ISOLA SW ALASKA
4400 SW ALASKA STREET

DESIGN REVIEW
DPD #3014486
FEBRUARY 6, 2014

ITEMIZED RESPONSE TO EDG BOARD COMMENTS

ALLEY RELATIONSHIP

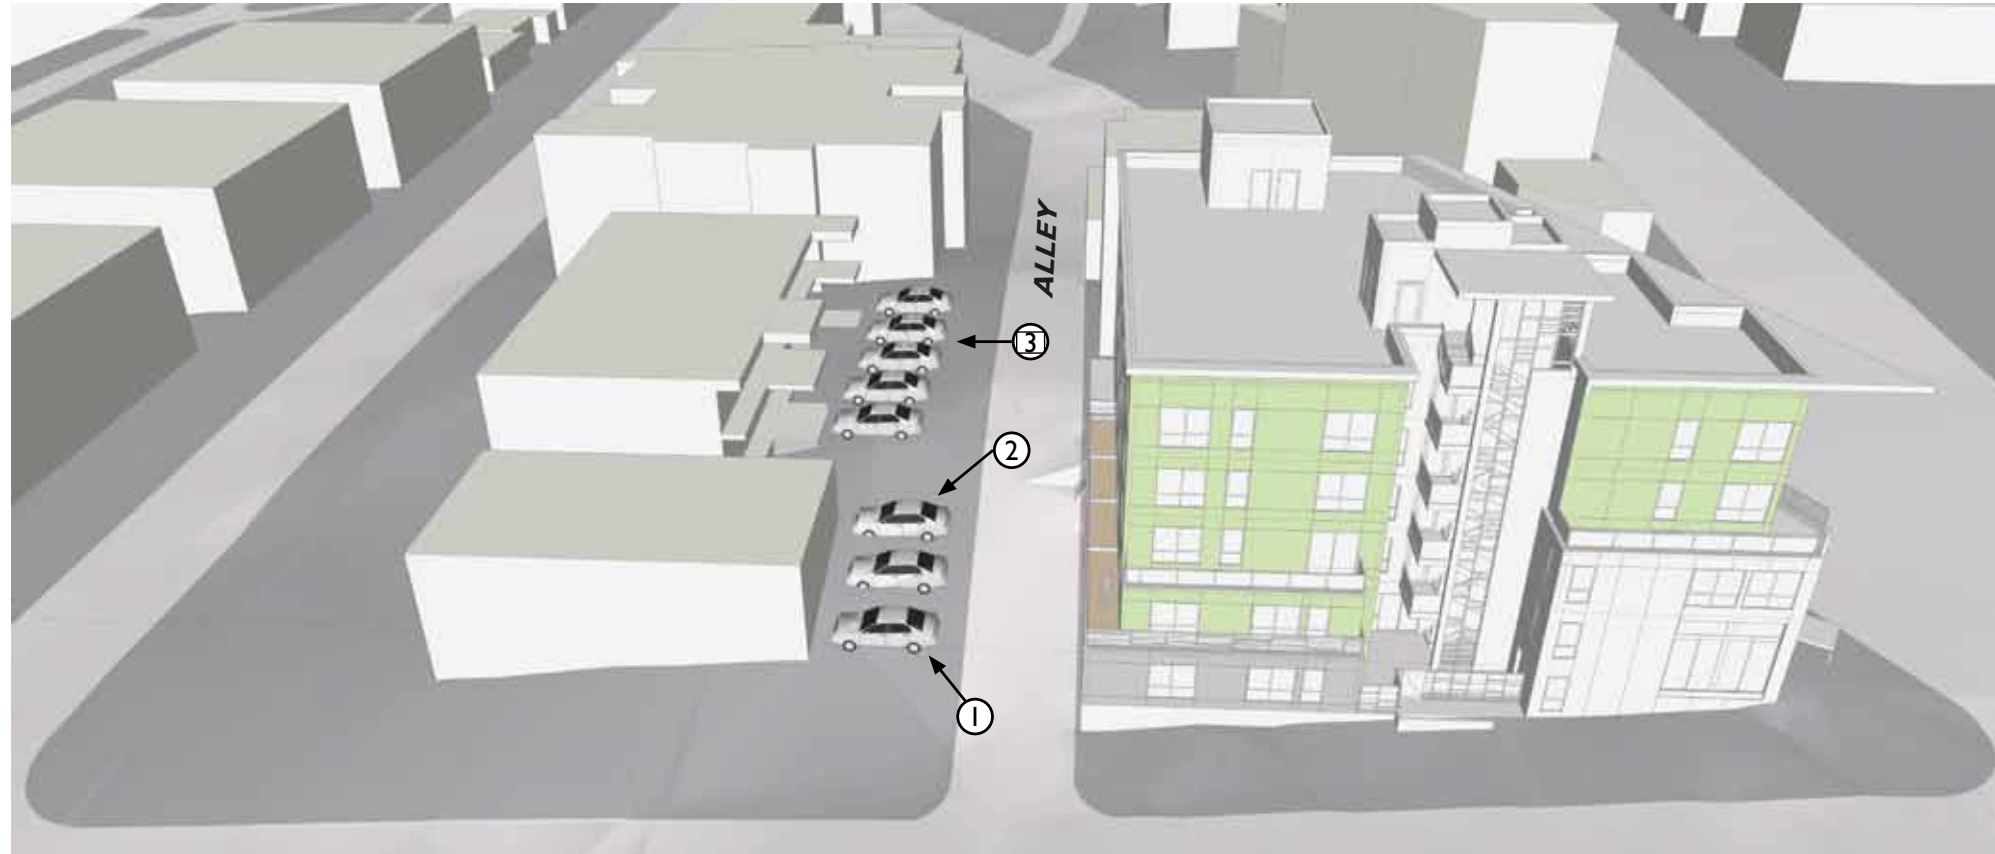
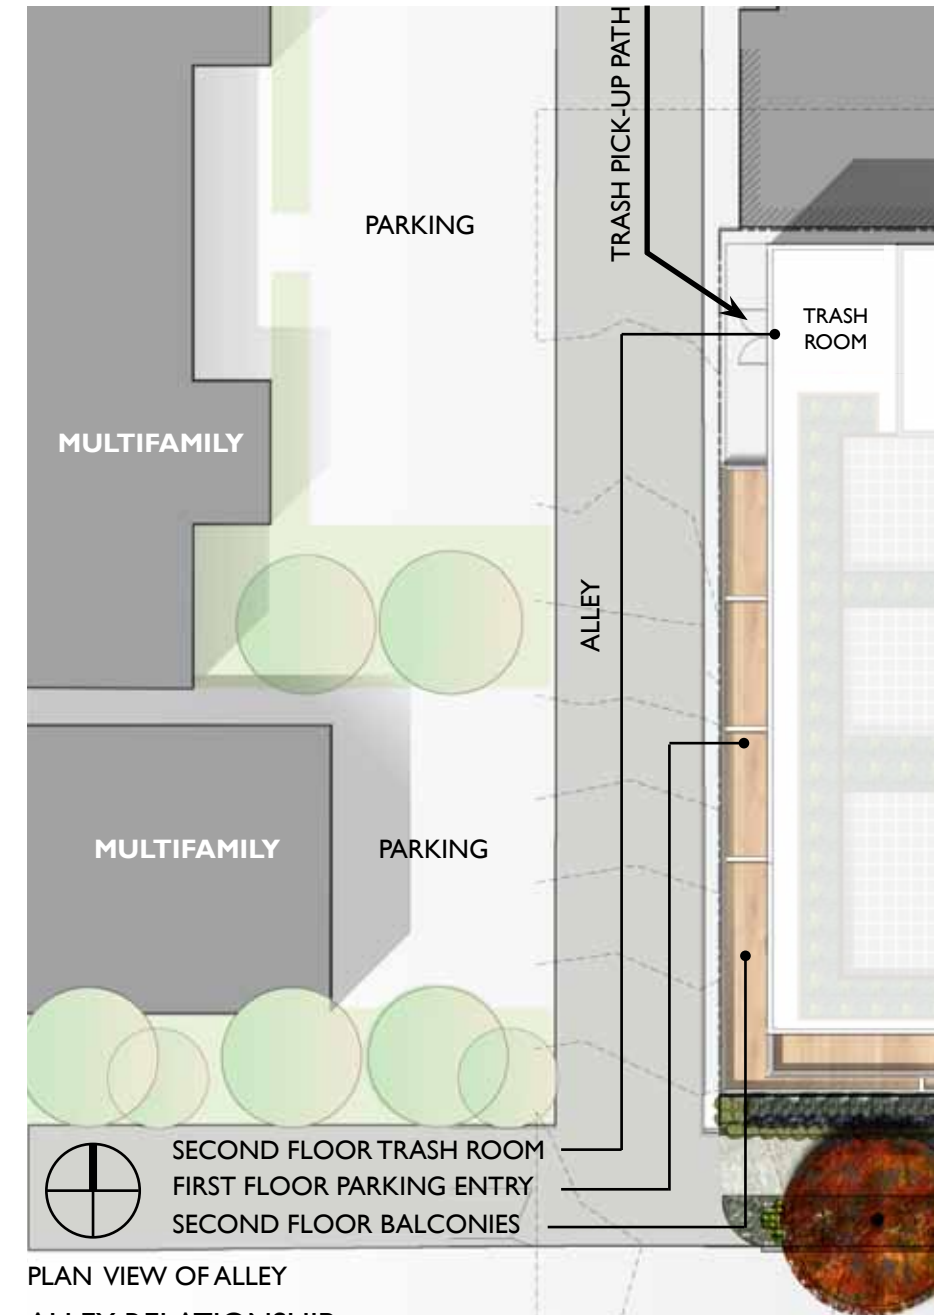
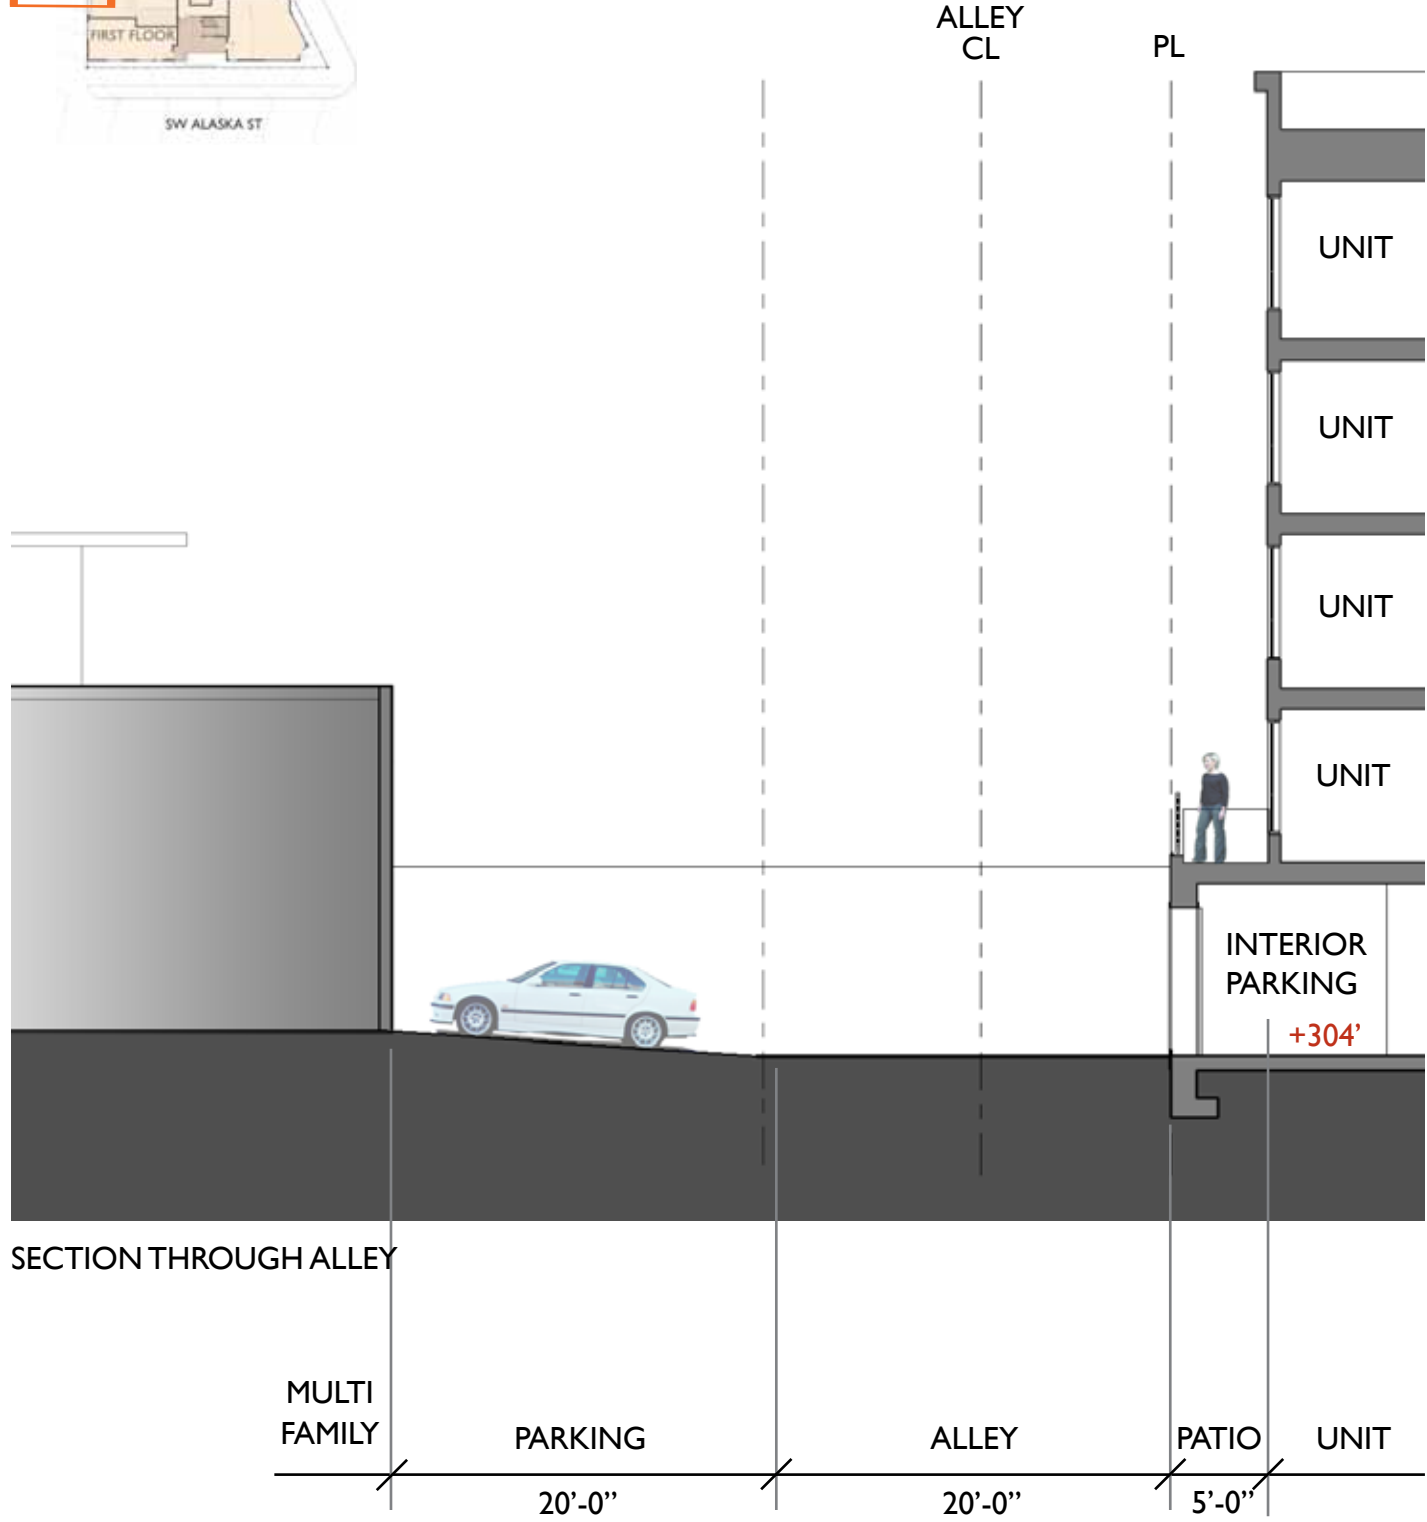
The Board requested more information on the treatment of the alley. The applicant will need to clarify the location of solid waste and recycling storage space and access to alley pickup. The Board would like to see the garage door proposed, as well as, the alley lighting concept to create safe spaces.

The alley context has been documented with pictures, perspectives, plan and section. Investigation shows that the alley side of the adjacent buildings is used for parking, and the facades are either blank, or used as exit corridors.

The proposed building locates the trash pickup at the highest point of the alley, which has been reviewed and approved by SPU as the best access point at the alley because it has the least slope. The garage door has been designed with a mesh material to provide air and daylight, as well as security via transparency. Lighting will be provided at both the trash door and at the garage door.

The 2nd story residential units have generous balconies facing out to the alley, detailed with wood slat guardrails. The balcony wraps around the southwest corner onto Alaska Street, giving meaningful scale to the residential units at this corner.
